**STATE OF CONNECTICUT
CONNECTICUT SITING COUNCIL**

Petition No. 1347A

July 28, 2020

**PETITION 1347A: GRE GACRUX LLC'S RESPONSES TO
THE SITING COUNCIL'S LATE-FILED EXHIBIT REQUESTS**

Erosion and Sediment
Control Plan - Overall

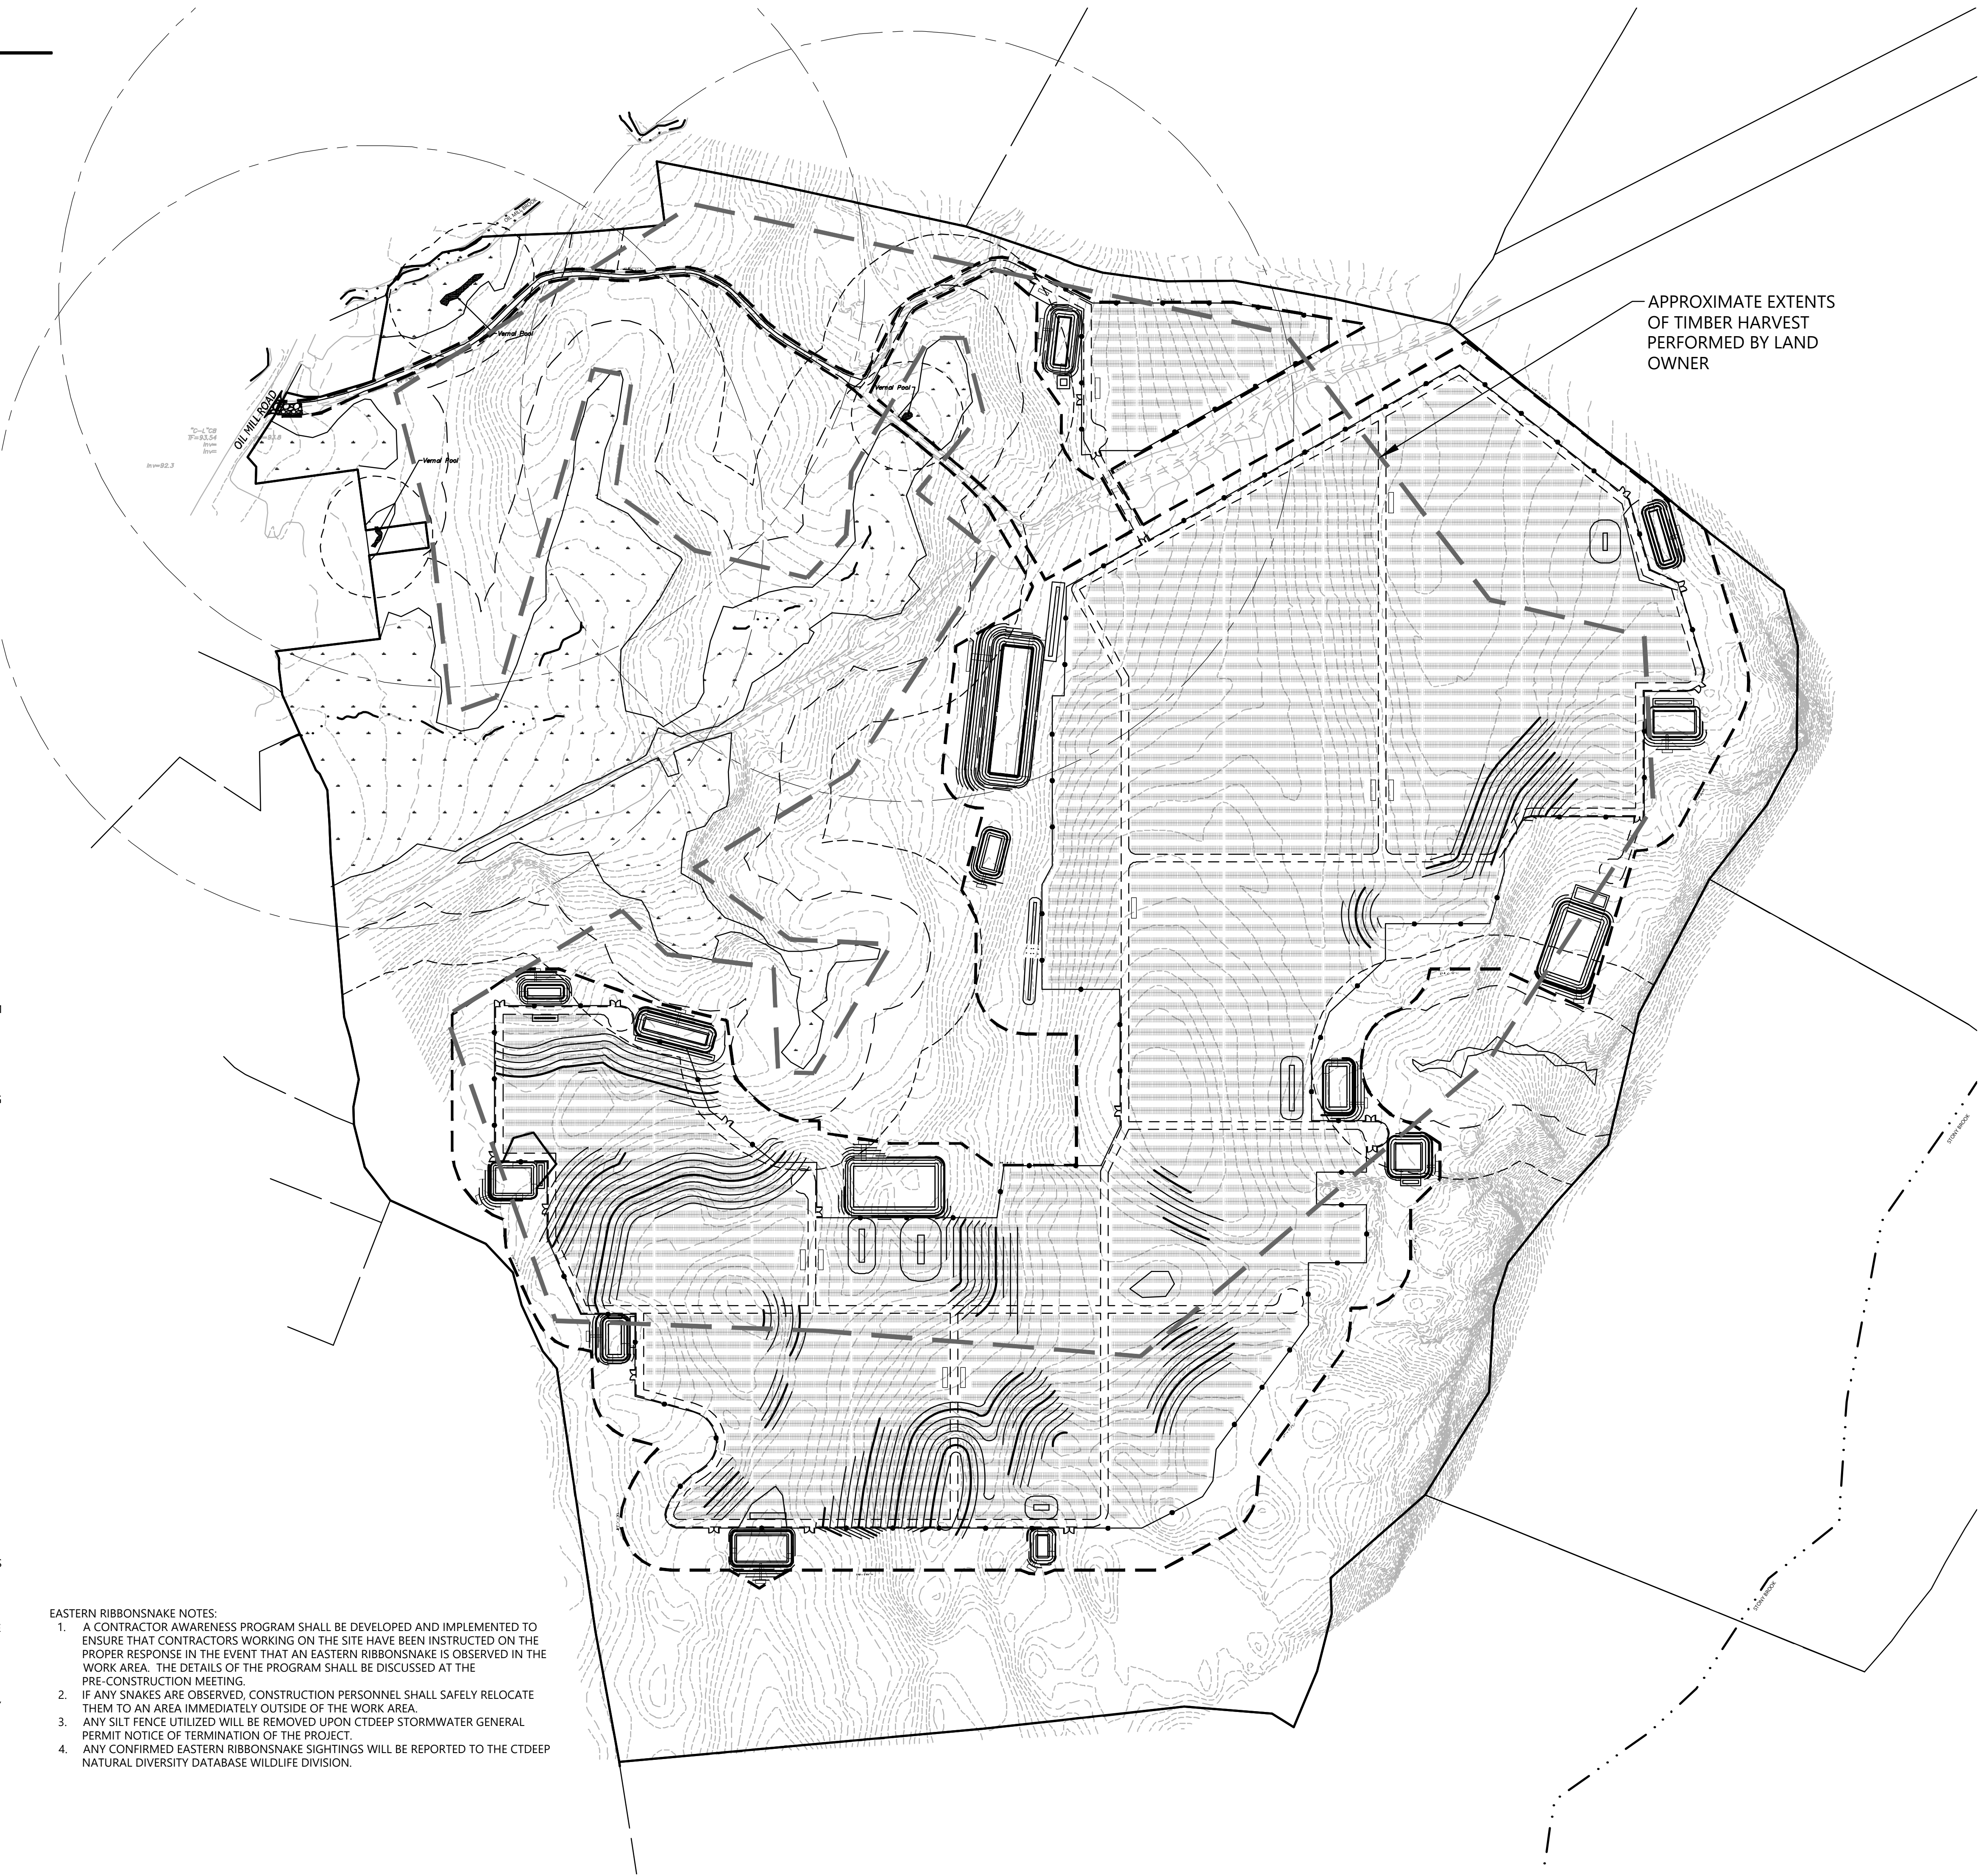
f) Revise Site Plan C-5.0 Notes to include inspections of E&S controls/basins (daily, weekly, and prior to and after a storm events)

2) The Petitioner shall make clear that they will allow a growing season following construction and stabilization of the basins prior to initiation of solar development.

4) Construction notes shall be clear that "mass excavation" refers only to those parts of the site where proposed grades are shown.

The notes on Site Plan Sheet C-5.0 (included in Attachment B) have been revised to require the contractor to perform daily inspections of the erosion and sediment control features on the site. It has also been clarified in the notes that a CTDEEP-approved qualified inspector shall perform weekly inspections, at a minimum, and/or inspections within 24 hours of a 0.5-inch rainfall event.

Note 15 of the Pre-Construction Site Protection Sequence has been revised to state that the initiation of mass earthwork or solar development cannot take place until the disturbed areas from the erosion and sediment control sequence have been seeded and allowed to grow through a growing season. This note can be found on Site Plan sheet C-5.0.

Note 1 of the Construction Sequence on Site Plan sheet C-5.0 has been revised to note that mass earthwork shall only mean regrading to meet the proposed grading depicted on the plans.
